CENWP-OD-JD

MEMORANDUM FOR THE RECORD

SUBJECT: 17JDA08 MFR – Two dead adult and three dead juvenile chinook found on the PH tailrace deck next to spillway # 20, within the last 4 days.

Photo is from the previous JD MFR03 to show the area.

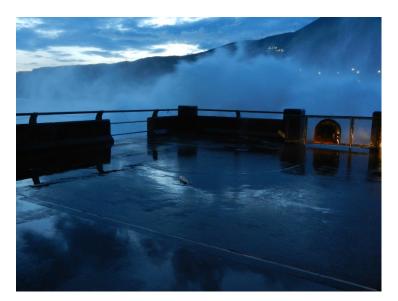
- F. Cause and Time of Death Asphyxiation due to stranding on deck
- G. Future and Preventative Measures After the second adult chinook mortality was found today, 23 May PM, the JD Fisheries imposed an immediate 3 stop limit at spill bay 20 to reduce its excessive and violent flows. A long term measure could be adding a small size mesh's screen on top of the hand rail. Probably up to extra 10 feet in height should be sufficient in preventing fish from being thrown over the current, low hand rail (pictured below.)
